Section 42A Officer's Final Reply (Topics 1 – 6)

Proposed Plan Change 1 — Regional Coastal Plan — Kermadec and Subantarctic Islands

Report prepared by: Jesse Gooding

8 July 2026

Figure 1 — Marine Chart NZ2862 – Plans in the Auckland Islands

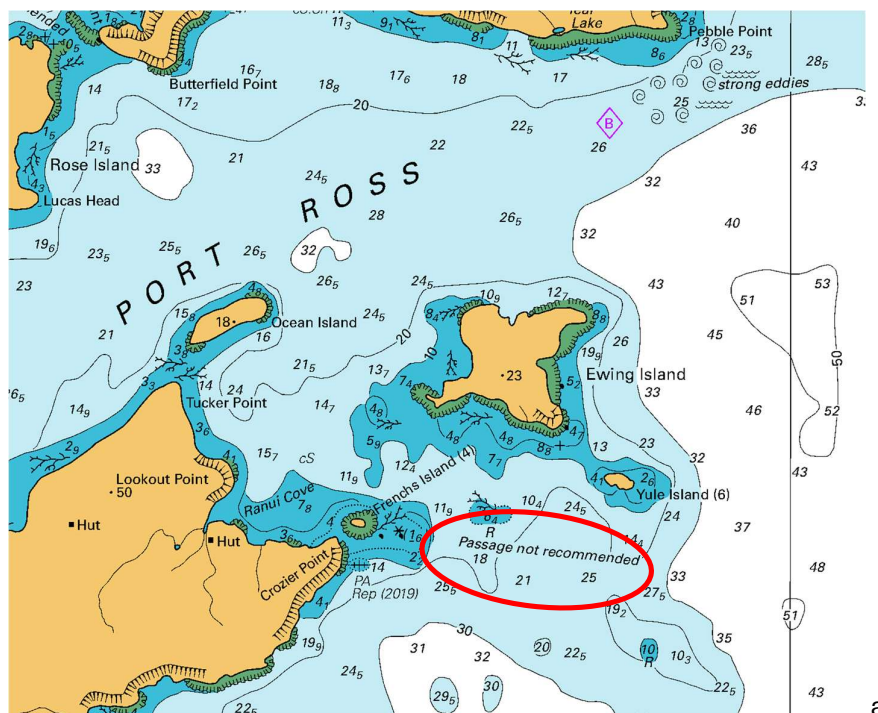
63. In his oral evidence at the hearing on behalf of Seaeagle Fishing Limited Mr Penwarden commented on the marine chart NZ2862 – *Plans in the Auckland Islands*. Mr Penwarden implied the label “passage not recommended” shown on that chart in Figure 1 below indicates that vessels should not access Ranui Cove from a southern approach, and that instead they would need to navigate to the north of Ewing Island, to reach the Ranui Cover anchorage, thereby accessing the Port Ross winter closure area shown on Map 2 of the proposed Plan, in breach of the applicable permitted activity rules (if doing so in the winter months).

64. Mr Dilley has addressed Mr Penwarden’s concern in Appendix A.²⁸ His advice is that marine charts must be read in conjunction with the relevant sailing directions, in this case, NP51 – New Zealand Pilot, the latest addition of which advises that the passage between “Ewing Island and Frenchs Island, 5 cables SW, has sufficient depth for the passage of medium sized vessels, keeping clear of the charted dangers.”
65. Mr Dilley’s advice is that subject to appropriate passage planning in accordance with Maritime Rule 23 (which makes voyage planning a

requirement) Ranui Cove can be safely accessed from this southern approach by medium sized vessels. Therefore, the claim that vessels have no choice but to enter the Port Ross winter closure area to access Ranui Cove appears to be based on an erroneous interpretation of the marine chart and/or NP51. In Mr Dilley's opinion, Ranui Cove remains a suitable alternative anchorage location to Port Ross, as confirmed by Mr Dilley in Appendix A.
